ENGINE - H.P. TURBINE ROTOR AND STATOR ASSEMBLY - INCORPORATE NEW STAGE 1 DUCT SEGMENTS
WITH IMPROVED CERAMIC COATING - CATEGORY CODE 6 - MOD.ENG-72-0108

V2500-ENG-72-0108

Location of Stage 1 HPT duct segments
Fig.1

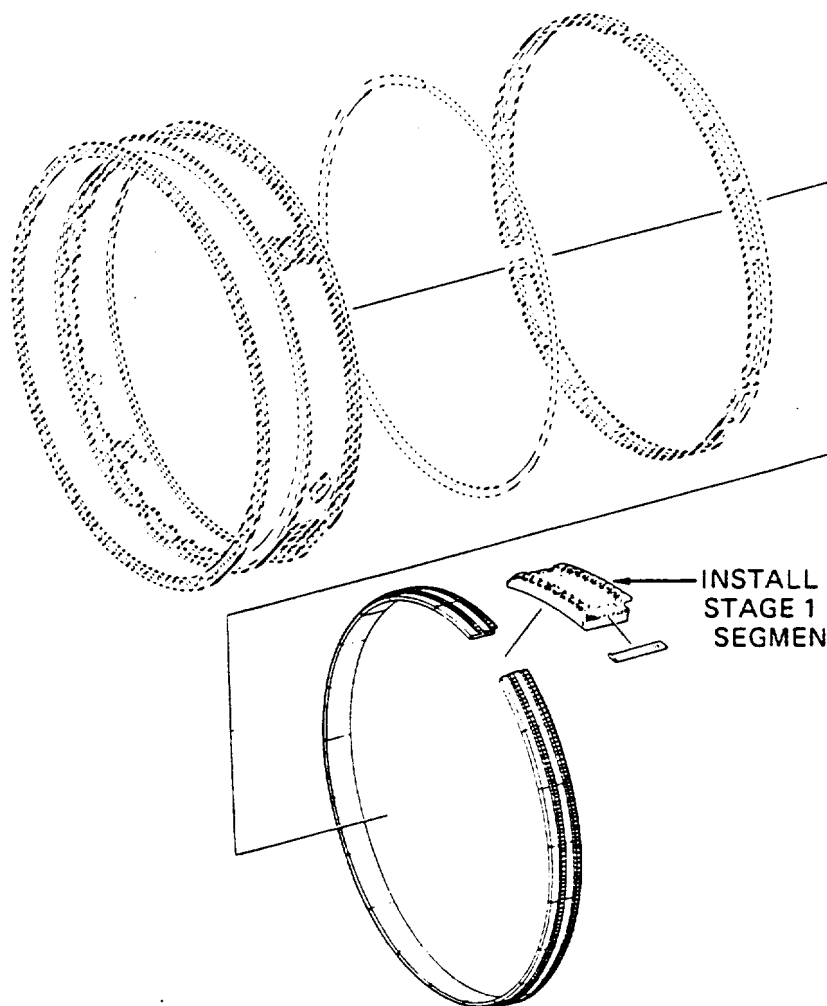
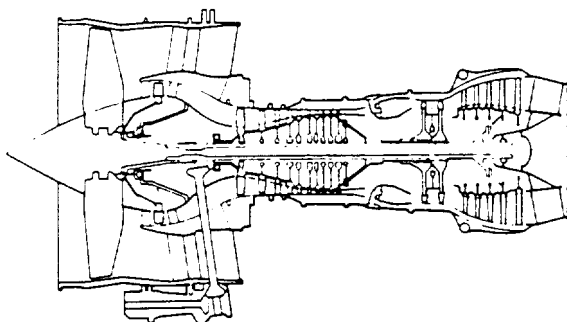
Erosion and Spalling of the coating on the current Stage 1 HPT Duct Segments can cause unacceptable blade tip distress causing degradation of engine performance.

- (1) A new Stage 1 HPT Duct Segment has been provided featuring improved coating to reduce erosion, spalling and blade tip distress which will enhance performance.

- (1) Replace the 2A1115 Stage 1 HPT Duct Segments with 2A1945 Stage 1 HPT Duct Segments (19 off) by the approved procedure in Reference (2), Chapter/Section 72-45-20, Assembly-01.

NOTE: The new Stage 1 HPT Duct Segments must be replaced in complete sets only. Do not mix the new segments with the old segments.
